Service Note		
Product	Description:	Service note no.
Mary (40200-GAB)	Voltage exceed specification	795 10 1881

This service note is only intended for TC-service Denmark/USA

Fig.1.

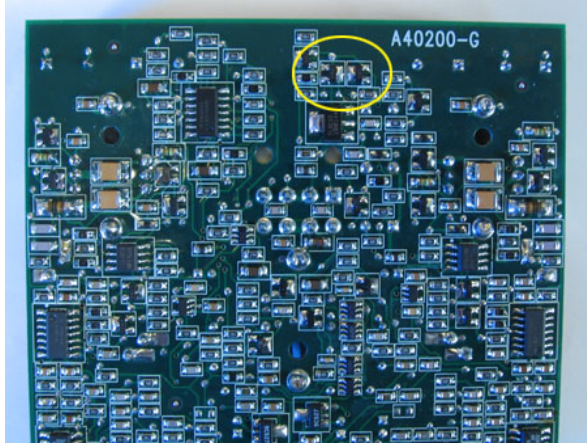
Fail rate still too high due to exceeded gate voltage and zener has been added for protection.

1. The location of the modified area on PCB-40200 fig.1.
2. Mount a Zener diode from Collector Q33 to Emitter on Q37 see fig.2
3. Cathode towards the Emitter Q37 see fig.3.
4. Always remember to update the unit to the latest software version. In this case you must have 1.64 or later.
